To: Glendale City Council

The City of Glendale's EIR for the Scholl Canyon Landfill (*Scholl Canyon Landfill EIR/Draft EIR, March 2014*) should not be approved because of an incomplete analysis of the geology of the site and surroundings of the landfill. The 2014 EIR is seriously flawed based on the following:

2.3.2 Bedrock Units

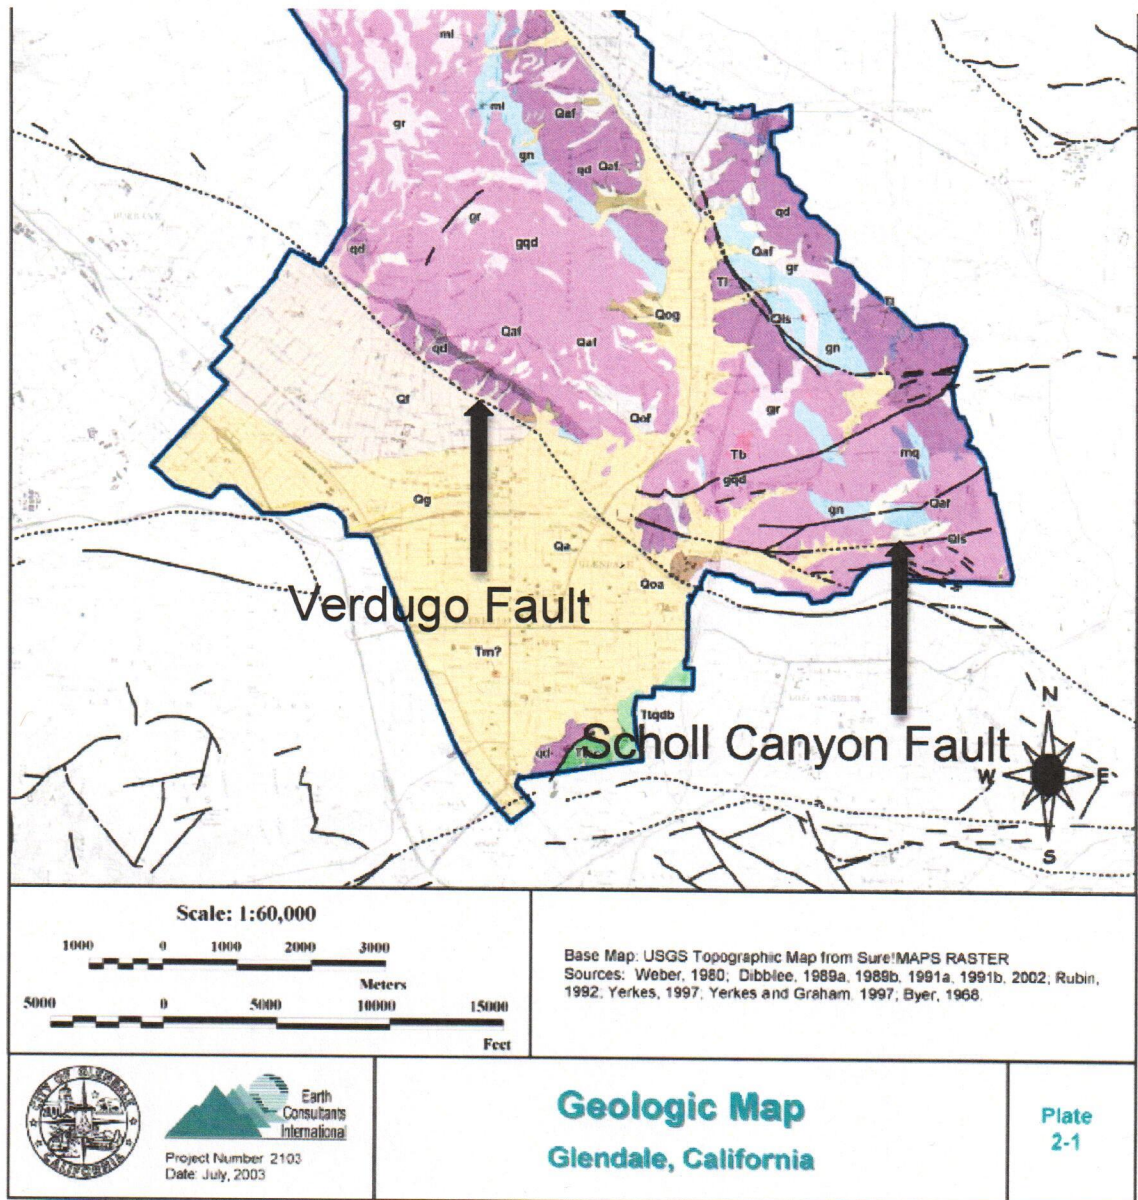
The 2003 SECGR clearly states that the bedrock is "highly shattered, sheared, and crushed". The substances of concern are simply flowing beneath the subsurface barrier at the mouth of the canyon through the fractured bedrock—confirmation of this is provided in Table 2 of the 2014 EIR (above).

(c) A geologic map in the 2003 SECGR provides evidence of another gateway for contaminated groundwater to flow westward past and beneath the western barrier of the landfill. The fractured bedrock along the fault plane of the Scholl Canyon fault (below, first named in the 2003 SECGR), is perpendicular to the western barrier and along the former westward trend of Glenoaks Canyon. The fault plane provides a pathway for contaminated groundwater to flow westward to Glendale's water wells.

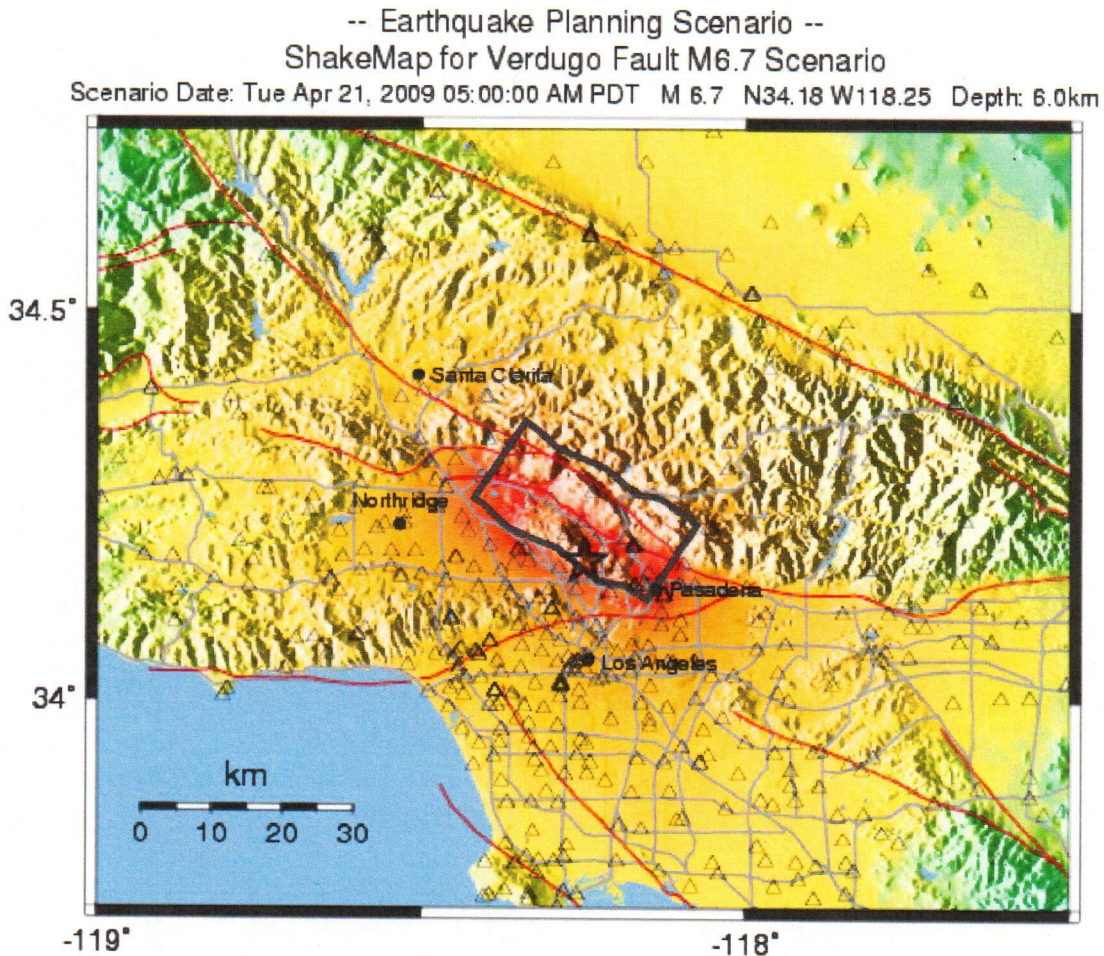
The Verdugo fault, with an earthquake capability of Magnitude 6.7 or from 6.0 to 6.7 (Southern California Earthquake Center [SCEC]) is present along the 134 Freeway and less than 1 mile south of the two western barriers (concrete, faced with volcanic ash) located at the landfill. According to SCEC, there will be strong to violent shaking in the epicenter area during an earthquake (see below). The death toll can be between none and 25,000. An earthquake of 6.0 to 6.7 can easily rupture the barriers in the landfill, allowing westward flow of contaminants in the landfill. The extraction wells east of the barriers cannot and do not remove all of the pollutants, and these barriers weren't mandated and installed until after approximately 20 years of rubbish and chemicals had been dumped at the site of the landfill.

The active San Andreas fault (northeast corner of the map below) with a magnitude of 7.8 earthquake capability, the San Gabriel fault with a M 6.7 or higher earthquake capability north of La Canada, and the Santa Monica-Hollywood-Raymond fault with a 6.7 magnitude capability just south of the landfill, and near near Broadway, are all capable of generating ground movement during an earthquake that could rupture any barriers at the landfill.

The 2014 EIR does not consider or adequately consider the earthquake capabilities of these faults that could rupture the barriers and release contaminants into the groundwater and Glendale's water wells.
